Helios responses to feedback received both during the Coordination Committee pre-meeting held on 17 August 2017 and post-meeting

1.11 Towing

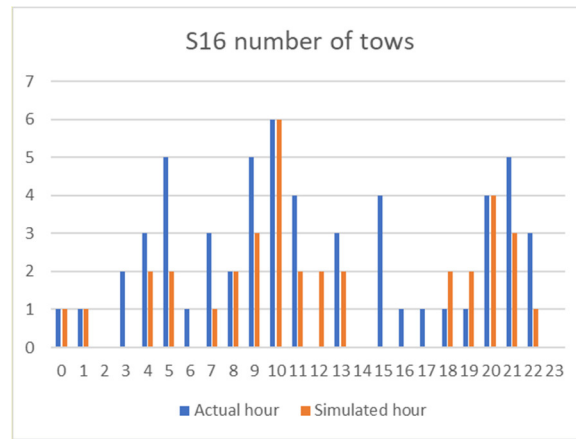
“Towing is not represented fully in the Helios modelling.”

“How many towing movements occur during 1st wave?”

As the core focus of this analysis is not on towing operations, towing is represented in the model to the extent that allows us to capture its negative impact on taxi times of other traffic. Comparison of actual hourly number of tows against simulated number of tows per hour (in our S16 baseline model) make us believe the model is fit for purpose with regards to impact of towing operations. It should be also noted that “fit for purpose” in context of fast time simulation has a different meaning to “indistinguishable from reality”. Comparison of actual and simulated number of tows in S16 baseline model is provided in the graph below
